Memorandum

TO: Roderick Sanchez, Development Services Director  
FROM: *Mike Frisbie*  
SUBJECT: 2015 UDC Update Proposal(s)  
DATE: *May 1, 2015*

## 2015 Annual Update Proposed Amendment Form

6. **Summary of Changes: 35-506 (e)(7)** – To provide a graph to clarify what is meant by secondary access

**Sec. 35-506 (e)(7) Secondary Access**

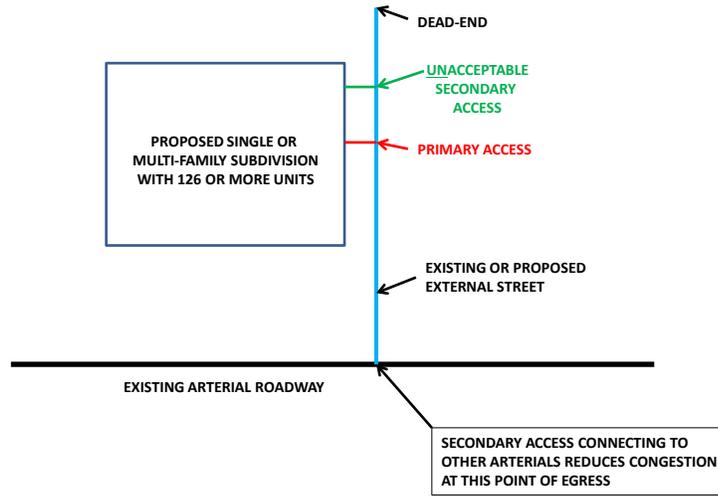
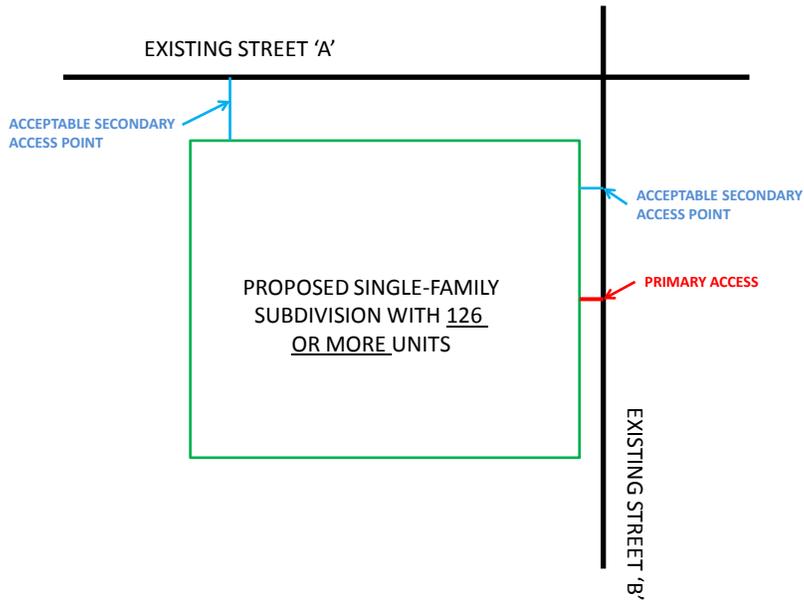
**Reason for Proposed Changes:** Consistency with interpretation of what is meant by secondary access by City staff and County.

(7) **Secondary Access.** At least one (1) access point into a single-family residential subdivision shall be provided for every two thousand six hundred forty (2,640) feet (one-half mile) of frontage. Where ~~a single-family residential or multi-family subdivision exceeds~~ one hundred twenty-five (125) ~~dwelling units~~ **peak hour trips are generated by a development**, a secondary access will be required. The secondary access shall meet the same requirements as the primary access (an entry for emergency purposes only shall not be allowed in place of a secondary access.)

**Current interpretation by some staff:**

**Proposed Figure to add:**
